Serene Conservancy status

from Dr. Ed Holroyd, former caretaker.
eholroyd@juno.com

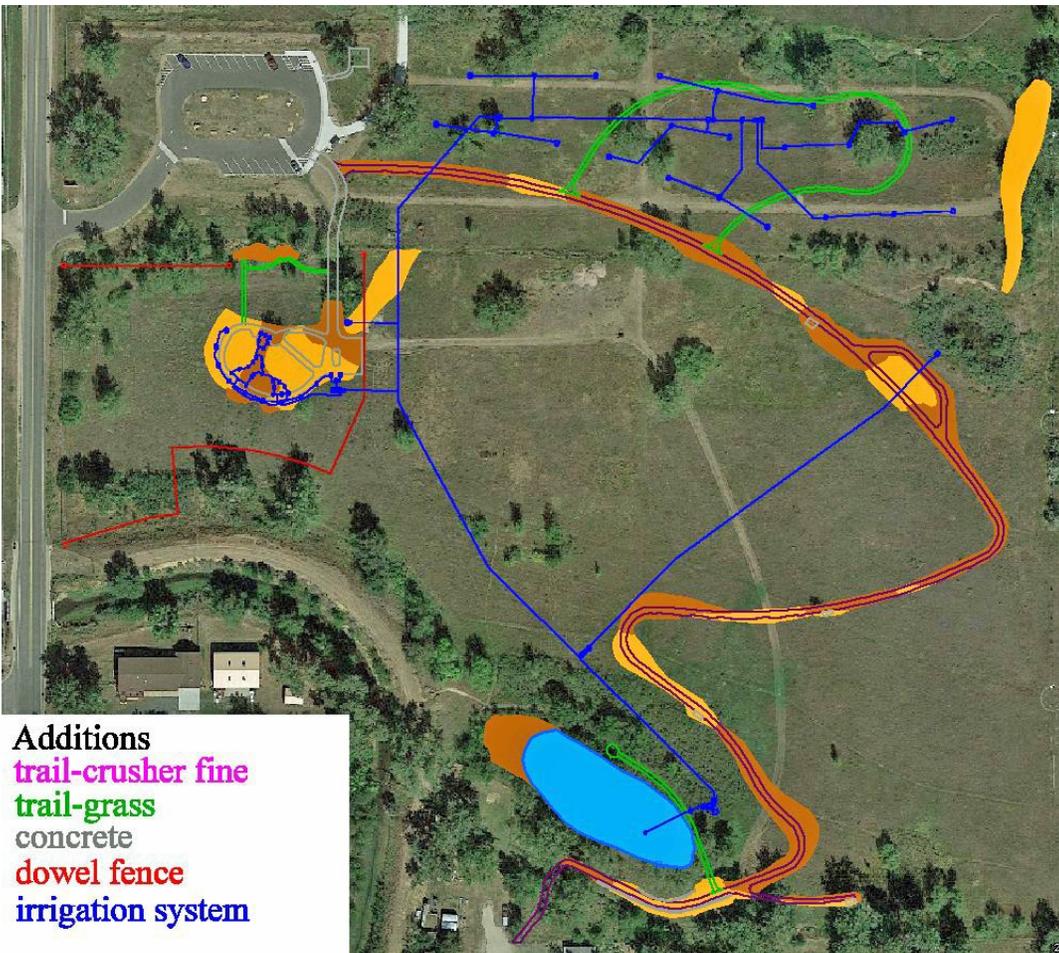
Disturbances
 total loop removal
 pond excavation, lining
 cuts
 fills
 ponds, creek

The gravel loops in the lowlands, presently used by walkers and pets, are to be totally removed, destroying their function as a levee confining Van Bibber Creek. The replacement is a single curved path to the south made durable with fine gravel. There is also a small lowland loop of mowed grass, not durable for walking traffic.

The upper (south) pond is to be excavated, lined, with dirt replacement, to hold water temporarily for irrigation of the lowlands.

Main issue: Conservation Easement allows natural and agricultural uses and irrigation. The District is not choosing agriculture and its water needs. By definition, all natural areas must receive precipitation only. Therefore the plans for the irrigation system and lining of the south pond (which are costly) violate the natural status and waste water on prairie grasses that do not need it.
